Wisconsin Department of Transportation

Proposal #31: 9180-19-71, WISC 2015145
City of Oconto Falls
W. Highland Dr – E. Highland Drive
STH 22
Oconto County

This is Addendum No. 3, which provides for the following:

ADDENDUM NO. 3

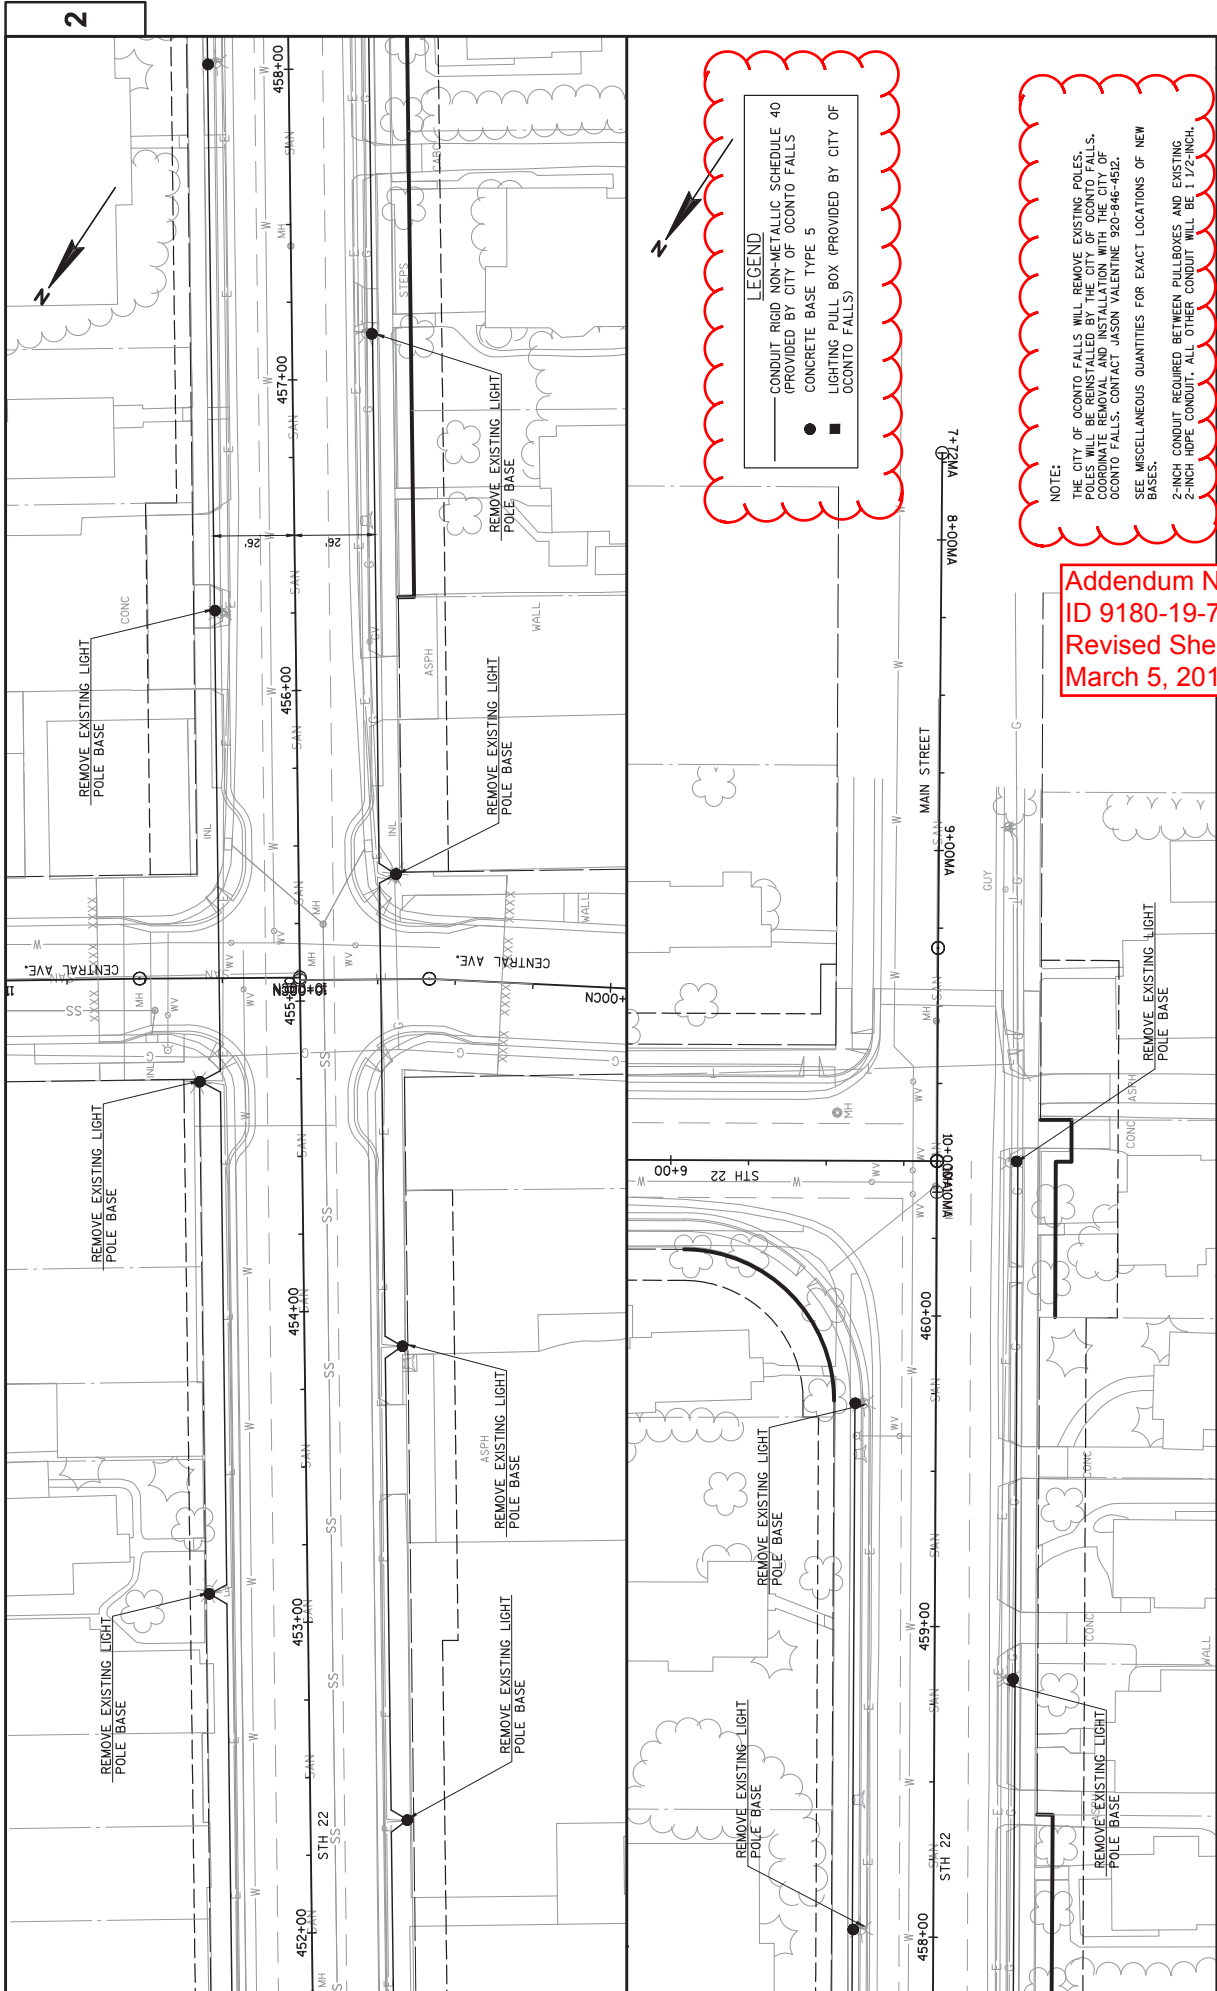
Revised Plan Sheets	
Plan Sheet	Plan Sheet Title (brief description of changes to sheet)
64	Lighting Plan – Added existing conduit to Caldwell Ave. intersection, revised new conduit, added pullboxes, revised notes, and legend.
65	Lighting Plan – Revised notes and legend.
66	Lighting Plan – Removed proposed conduit between Franklin Street and Washington Street, revised new conduit, revised notes, and legend.
67	Lighting Plan – Revised notes and legend.
120	Miscellaneous Quantities – Removed and added tables.

NOTE:
 THE CITY OF OCONTO FALLS WILL REMOVE EXISTING POLES. POLES WILL BE REINSTALLED BY THE CITY OF OCONTO FALLS. COORDINATE REMOVAL AND INSTALLATION WITH THE CITY OF OCONTO FALLS. CONTACT JASON VALENTE 920-846-4512. SEE MISCELLANEOUS QUANTITIES FOR EXACT LOCATIONS OF NEW BASES.
 2-INCH CONDUIT REQUIRED BETWEEN PULLBOXES AND EXISTING 2-INCH ROPE CONDUIT. ALL OTHER CONDUIT WILL BE 1 1/2-INCH.

Addendum No. 3
ID 9180-19-71
Revised Sheet 65
March 5, 2015

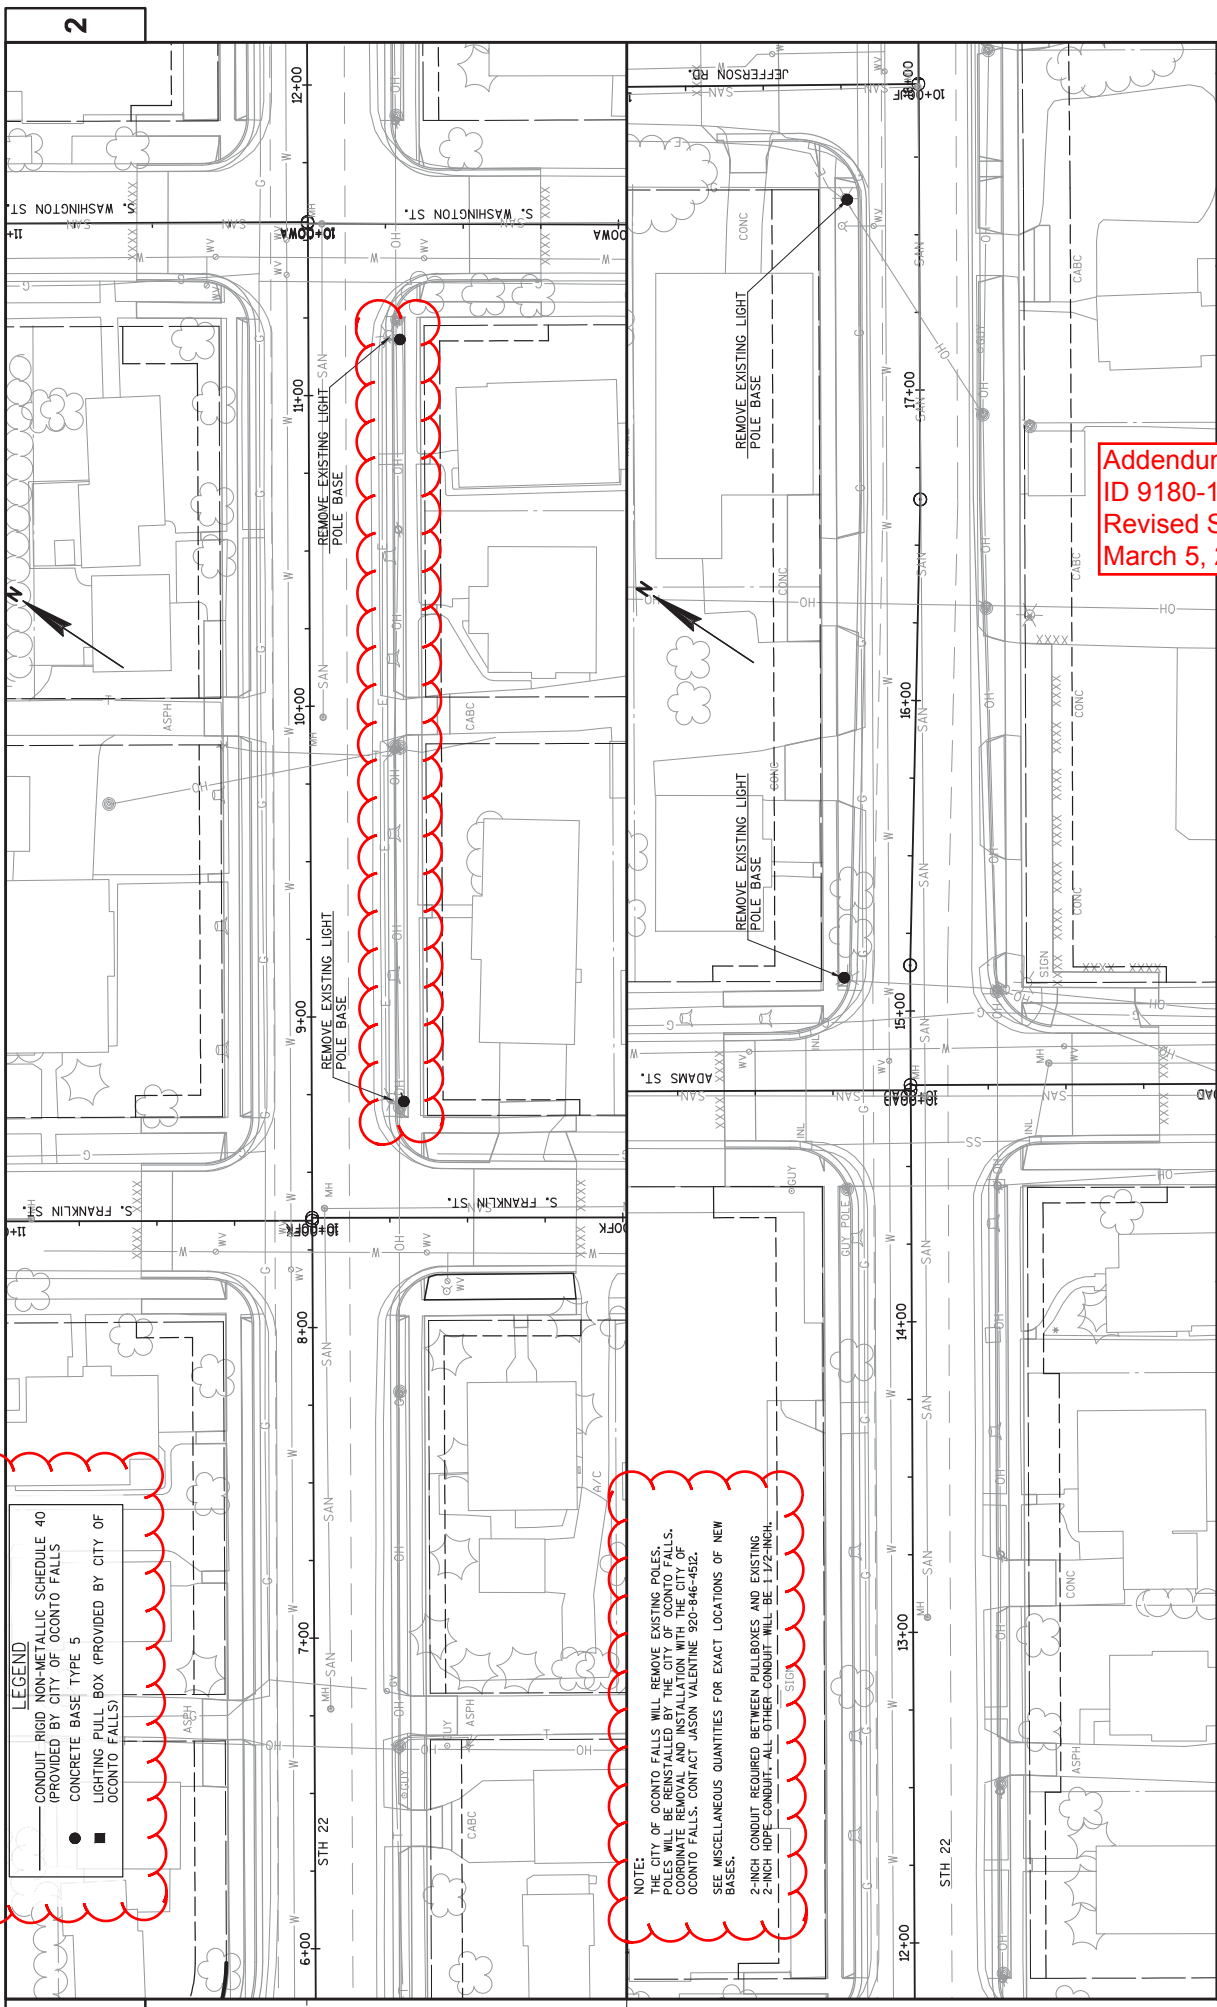
NOTE:
 THE CITY OF OCONTO FALLS WILL REMOVE EXISTING POLES. POLES WILL BE REINSTALLED BY THE CITY OF OCONTO FALLS. COORDINATE REMOVAL AND INSTALLATION WITH THE CITY OF OCONTO FALLS. CONTACT JASON VALENTE 360-946-4922.
 SEE MISCELLANEOUS QUANTITIES FOR EXACT LOCATIONS OF NEW BASES.
 2-INCH CONDUIT REQUIRED BETWEEN PULLBOXES AND EXISTING 2-INCH HOPE CONDUIT. ALL OTHER CONDUIT WILL BE 1/2-INCH.

Addendum No. 3
ID 9180-19-71
Revised Sheet 66
March 5, 2015

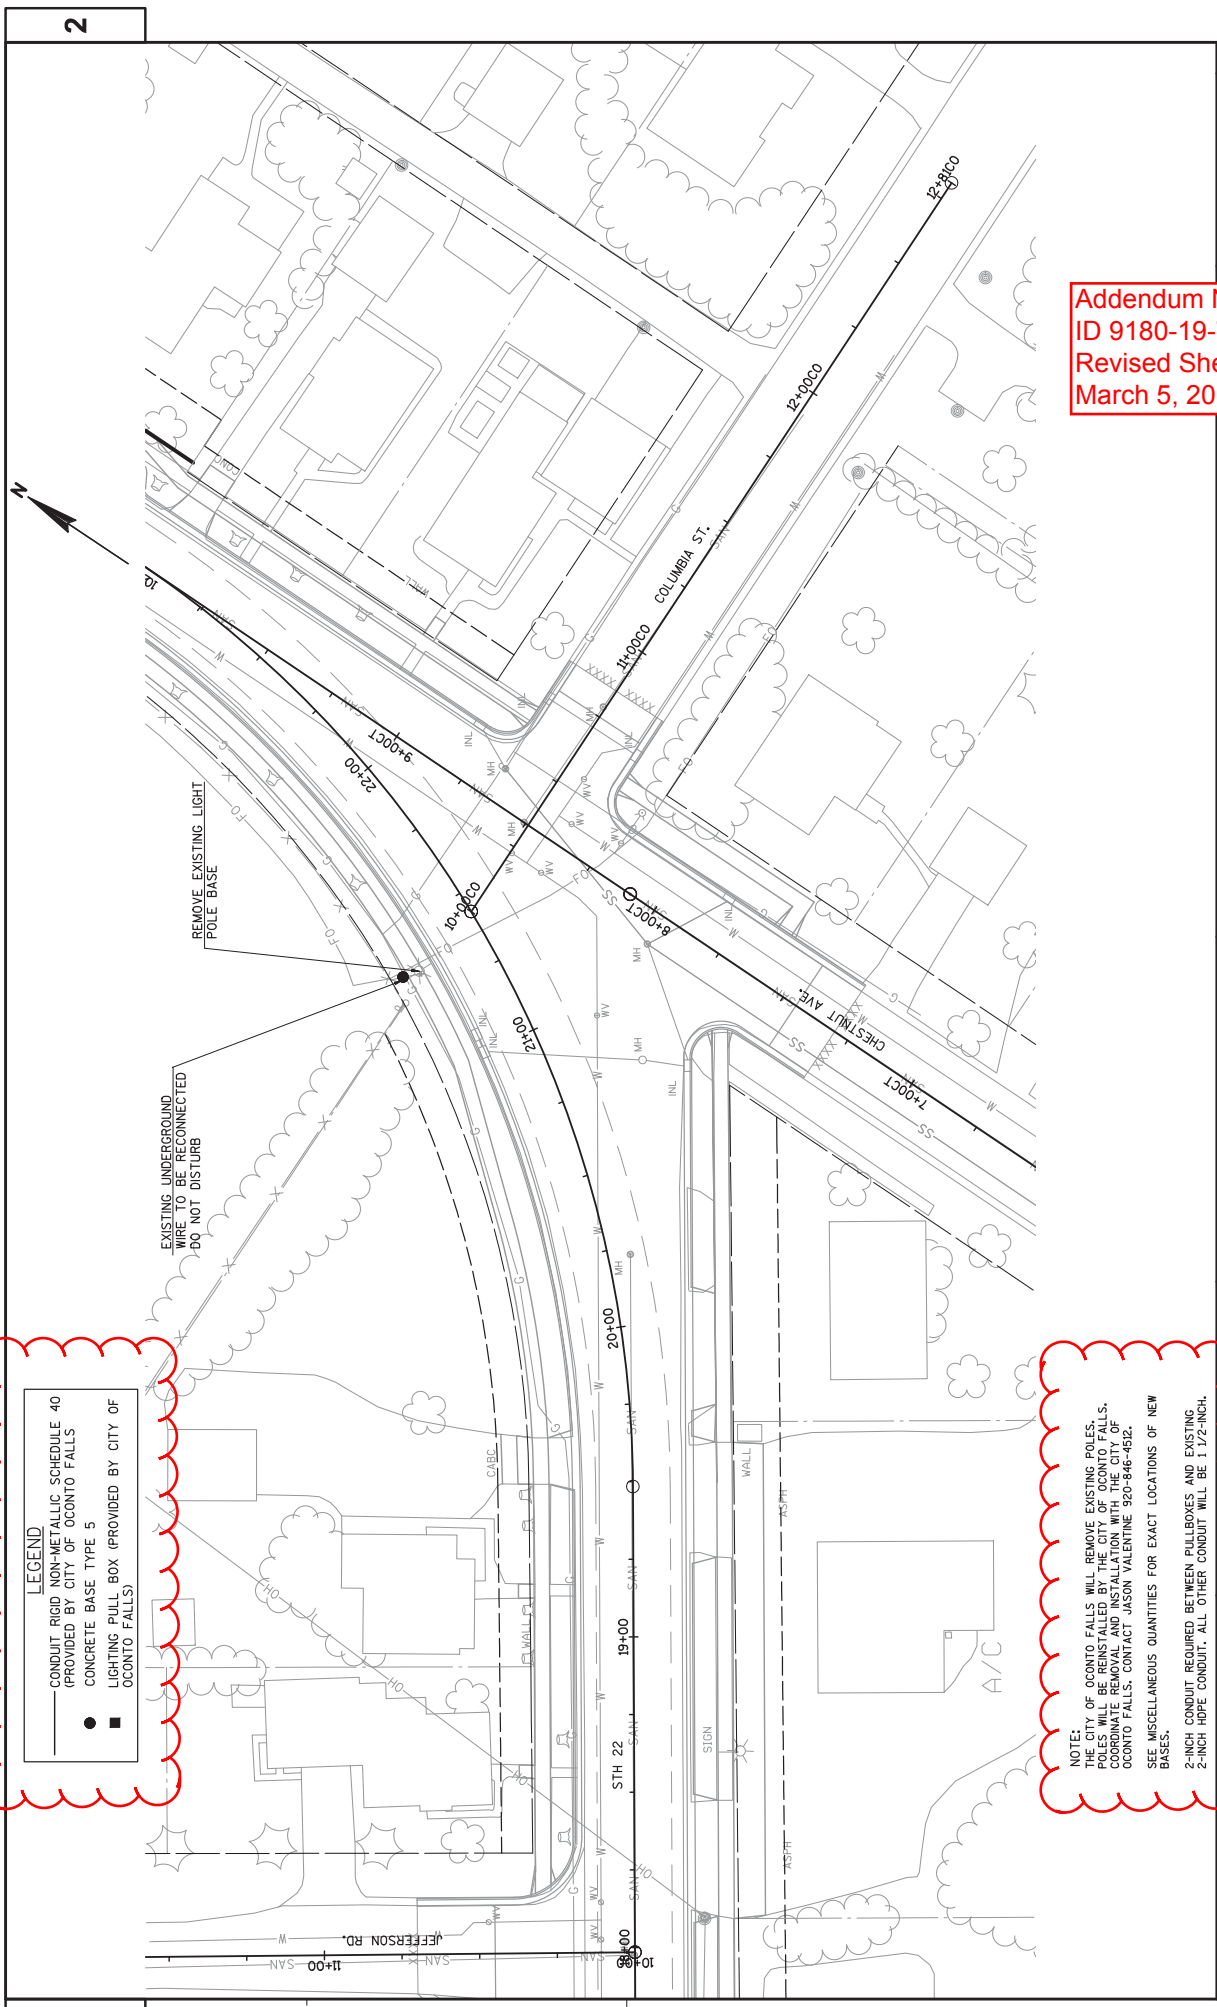
NOTE:
 THE CITY OF OCONTO FALLS WILL REMOVE EXISTING POLES. POLES WILL BE REINSTALLED BY THE CITY OF OCONTO FALLS. COORDINATE REMOVAL AND INSTALLATION WITH THE CITY OF OCONTO FALLS; CONTACT JASON VALENTINE 920-846-4912.
 SEE MISCELLANEOUS QUANTITIES FOR EXACT LOCATIONS OF NEW BASES.
 2-INCH CONDUIT REQUIRED BETWEEN PULLBOXES AND EXISTING 2-INCH HDPE CONDUIT. ALL OTHER CONDUIT WILL BE 1 1/2-INCH.
